AES-O-NRC-09-00079-0

AREVA Enrichment Services LLC
Eagle Rock Enrichment Facility
NRC Docket No: 70-7015

Subject: Response to Information Needs Identified by the U.S. Nuclear Regulatory Commission for the AREVA Enrichment Services Eagle Rock Enrichment Facility - Environmental Report

Figure 3.1-2 **Rev. 1**
~~Location of U.S. U308 Uranium Patents~~
EAGLE ROCK ENRICHMENT FACILITY ENVIRONMENTAL REPORT

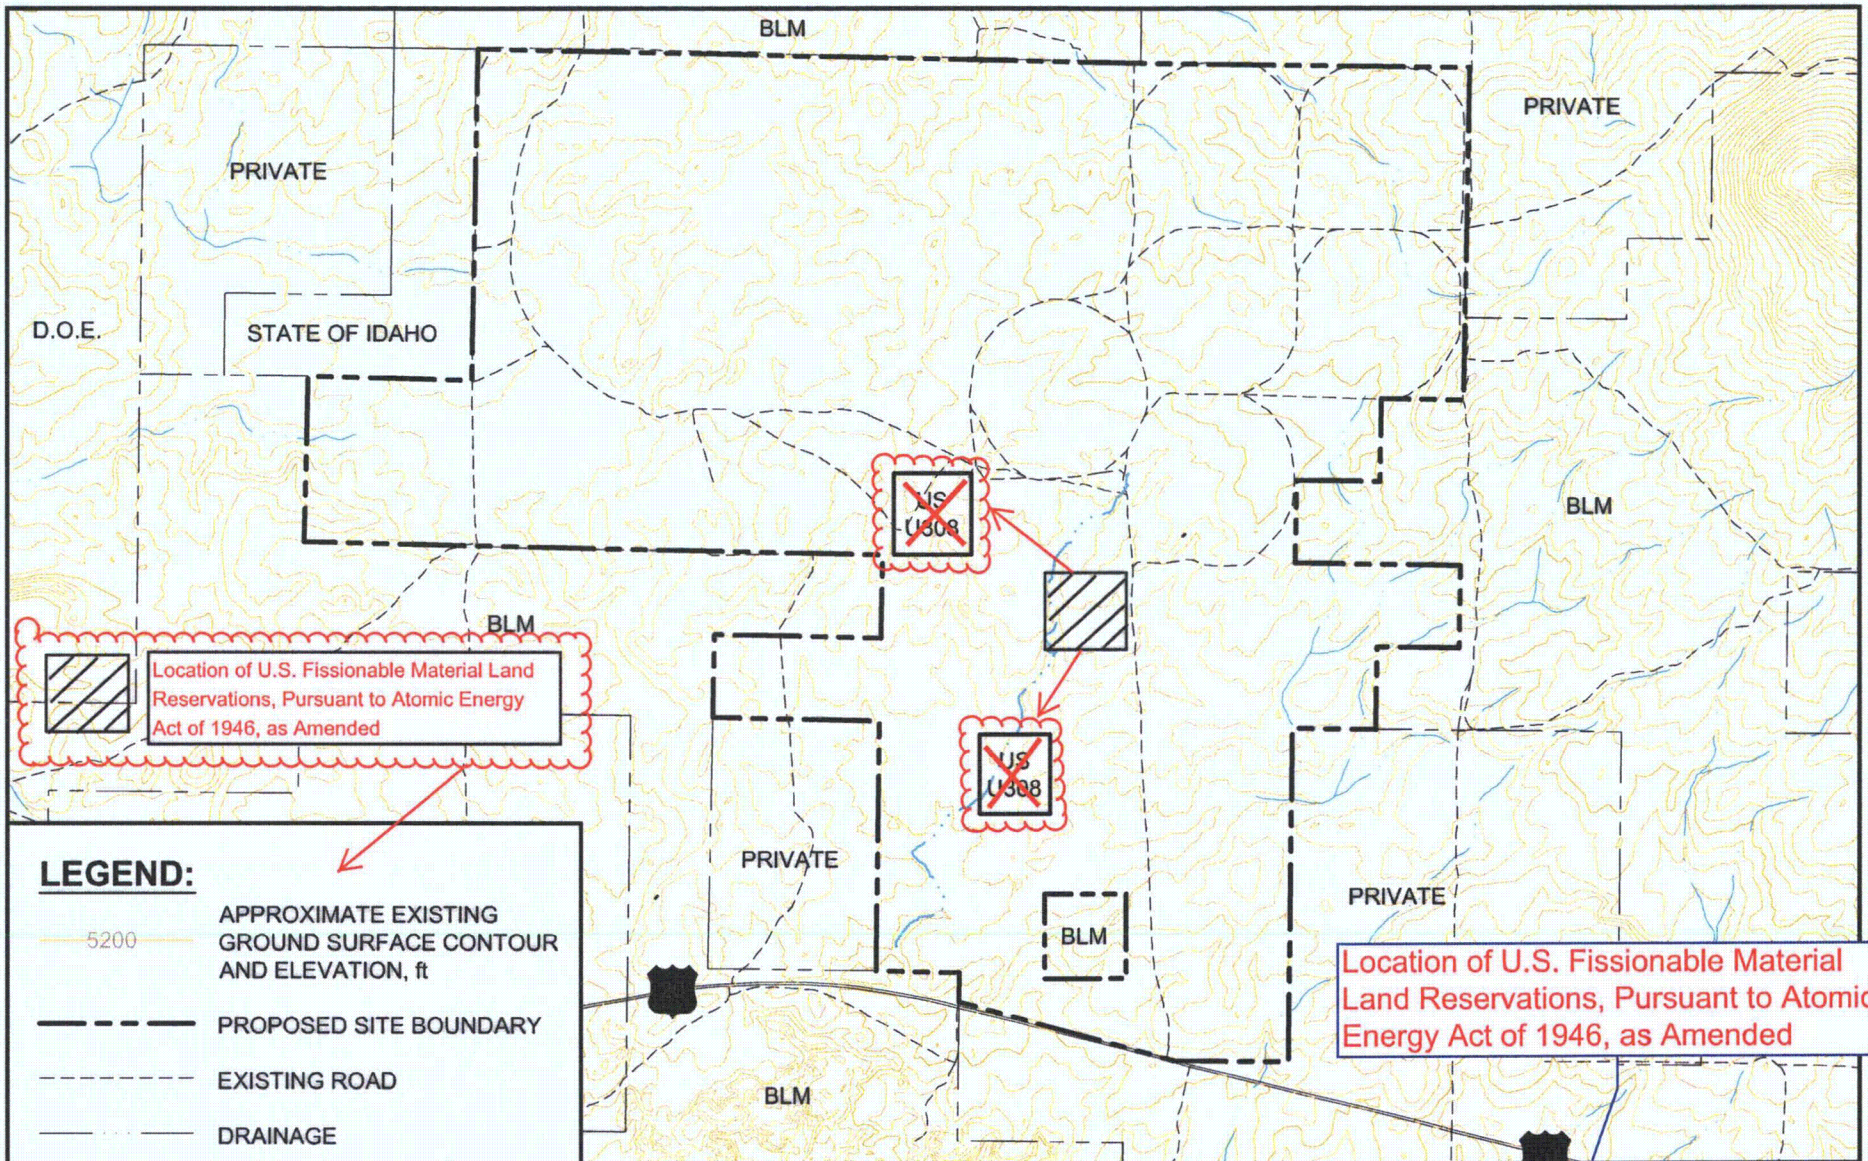
Section 1.2.1, Section 2.1.2.1, Section 3.1.1, and Figure 3.2-1 of the ER will be modified as shown in Attachment 1.2.

Attachment 1.2 provides the markup pages for ER Section 1.2.1, ER Section 2.1.2.1, ER Section 3.1.1, and ER Figure 3.1-2 of the EREF License Application.
